***82547GI/82547EI***  
***Gigabit Ethernet Controller***  
***Specification Update***

*June 23, 2006*

The 82547GI/82547EI Gigabit Ethernet Controller may contain design defects or errors known as errata that may cause the product to deviate from published specifications. Current characterized errata are documented in this Specification Update.

PCN 104210-00

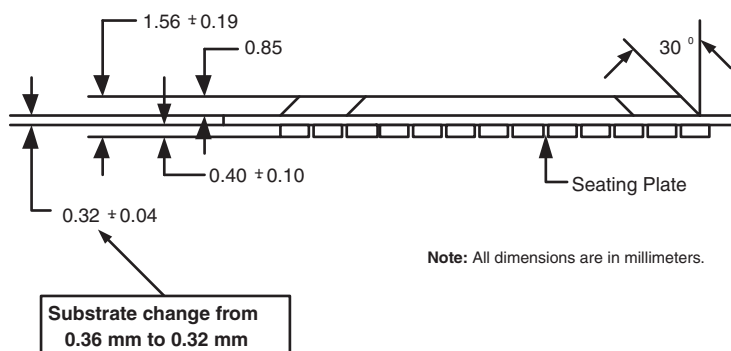
**Implication:** This migration allows flexibility with new substrate suppliers to support Intel demands on PBGA.

This migration does not affect fit, form, or function.
